**LAKE PONTCHARTRAIN  
HIGH LEVEL PLAN**

**DESIGN MEMORANDUM NO. 19A  
GENERAL DESIGN  
SUPPLEMENT NO. 1**

**LONDON AVENUE  
OUTFALL CANAL  
FRONTING PROTECTION  
PUMPING STATION NO. 4**

CELMV-PE-TG (CELMN-ED-SP/23 Mar 95) (1105-2-10c) 3d End Mr. Burkhard/cc/  
601-634-5930

FIG. 24

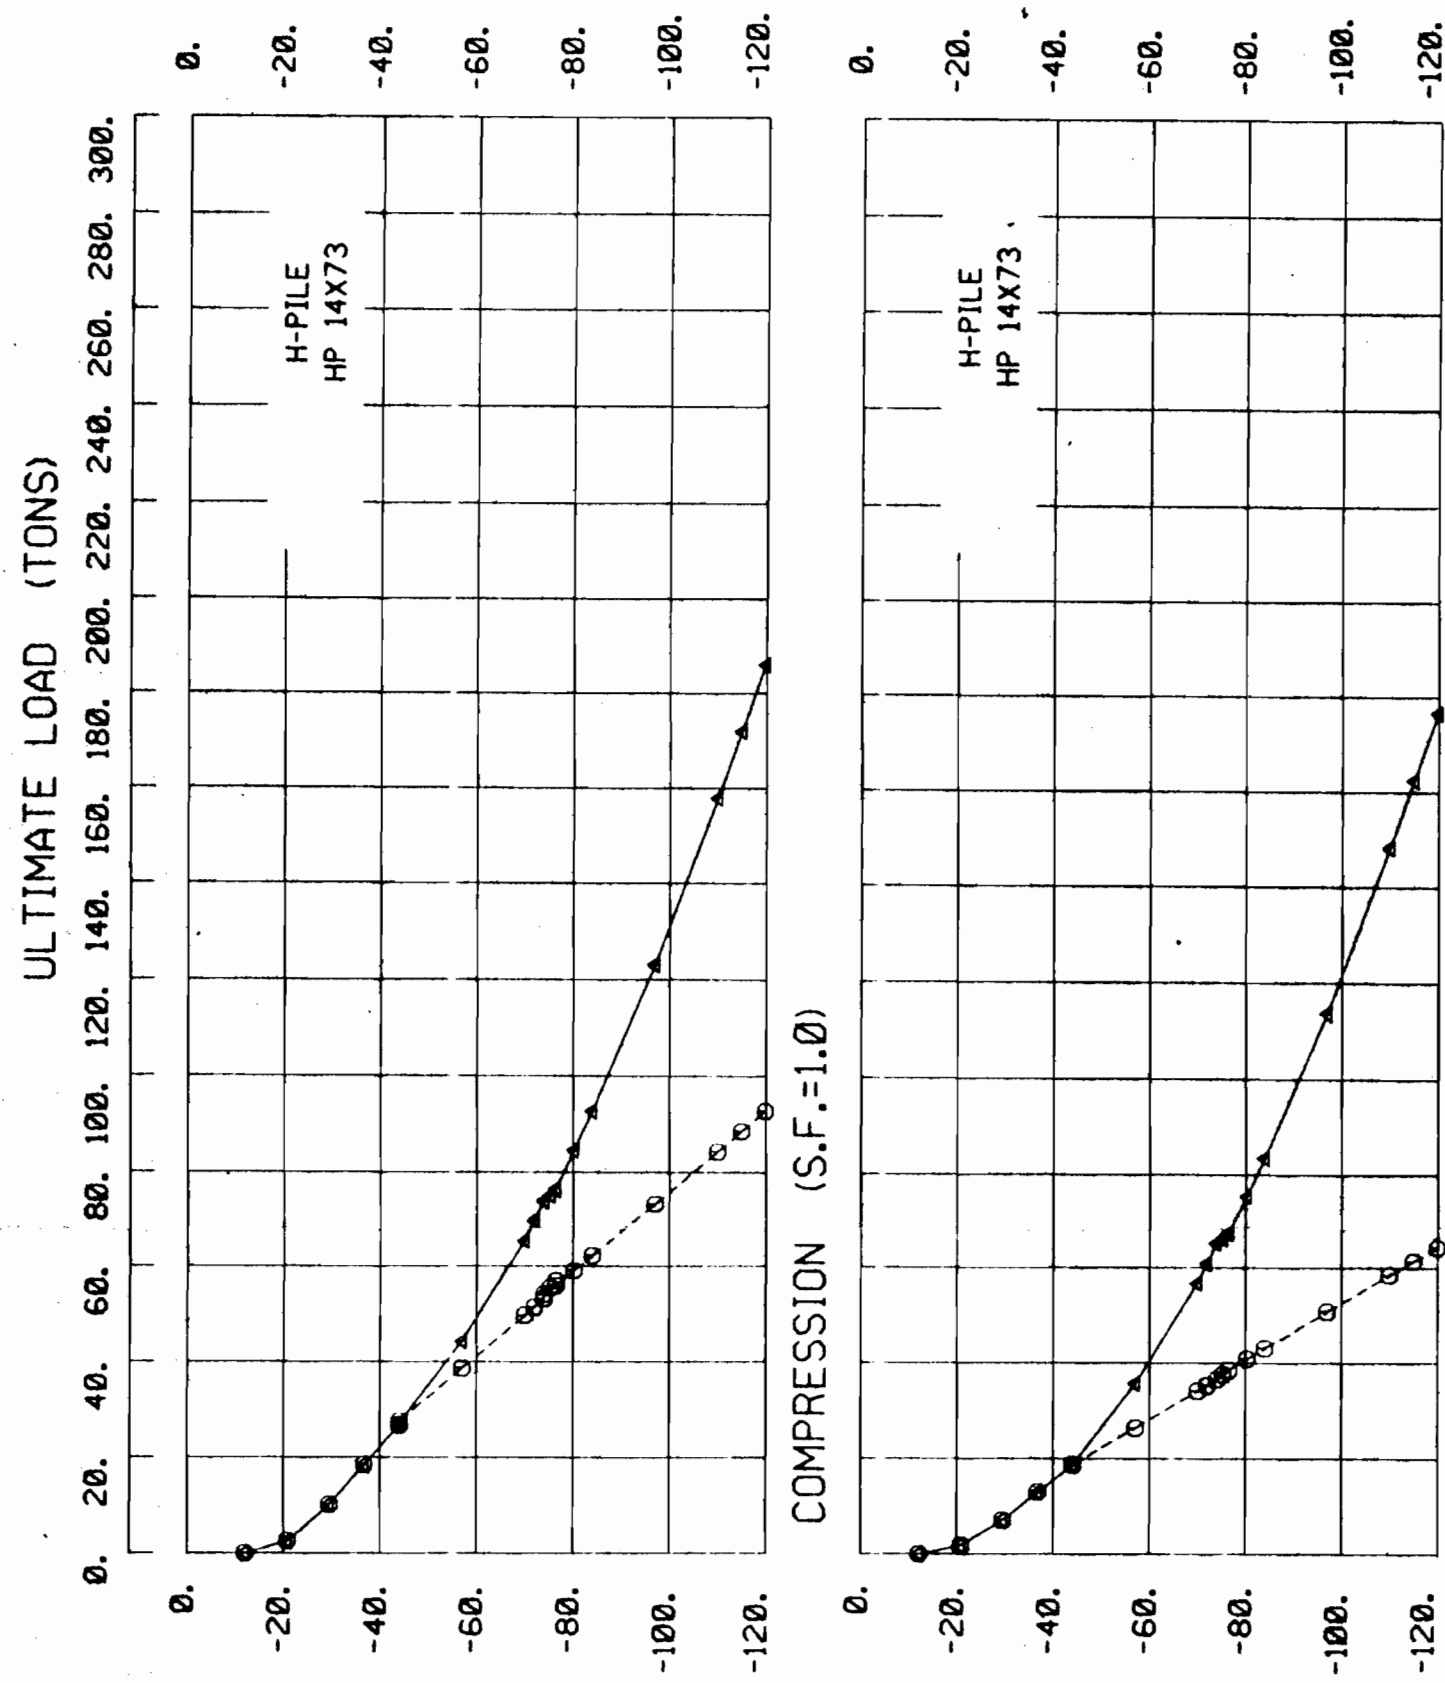
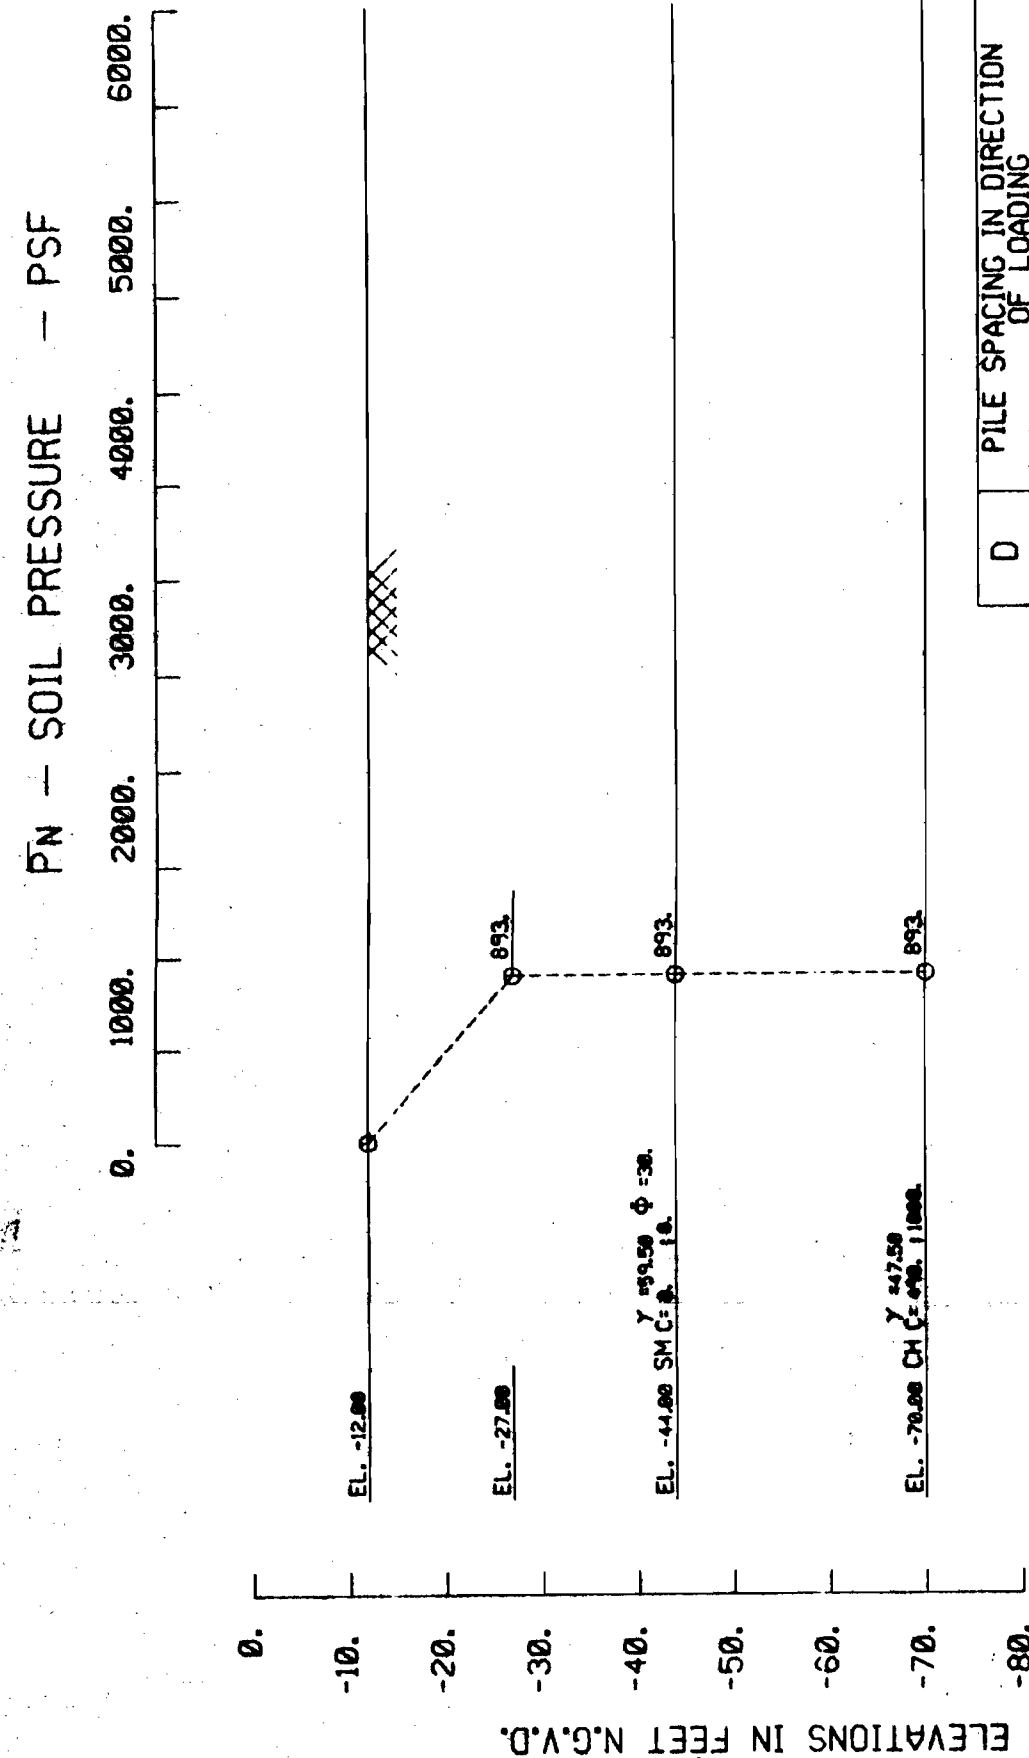
f. Page 25, para 37d, Table 3. Section 4-2.c of EM 1110-2-2906, Design of Pile Foundations, 15 January 1991, states that the minimum factor of safety to be used in determining the design pile capacity under an "unusual" loading condition is 1.5 if verified by pile load test and 2.25 if not verified by pile load test. This table as well as Plates 24 and 25 should be revised to reflect this.
